# MSATS STANDING DATA REVIEW

FINAL REPORT AND DETERMINATION

Published: **7 September 2020**

Figure 2: Alternative Proposal

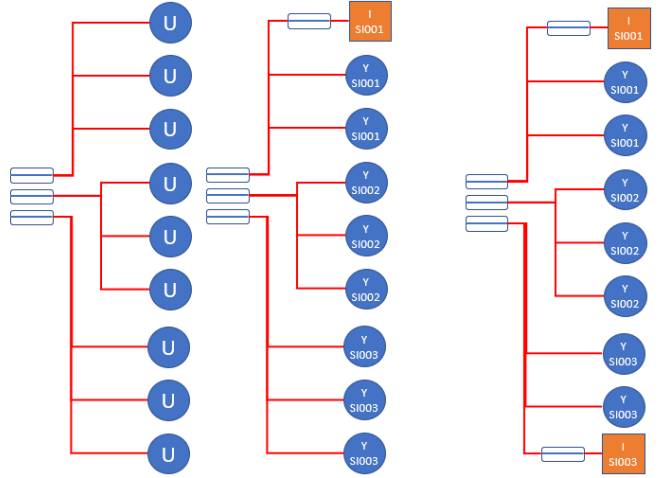
No.	Consulted person	Heading	Respondent Comments	AEMO response
			<p><b>Alternative</b></p> <p>Initial State – LNISP doesn't know isolation arrangement Flag bulk populated U</p> <p>First Installation – MP visits site, identifies Shared isolation, Network visits site, identifies affected customers, network isolation organised, smart meter installed with individual isolation. All sites identified.</p> <p>Second and subsequent isolation MP can see from Flag and Index that Network Isolation required Network. <b>Network does not need to visit site to do reconnaissance, appointment set only for customers connected to SI003 Shared Isolation</b></p>
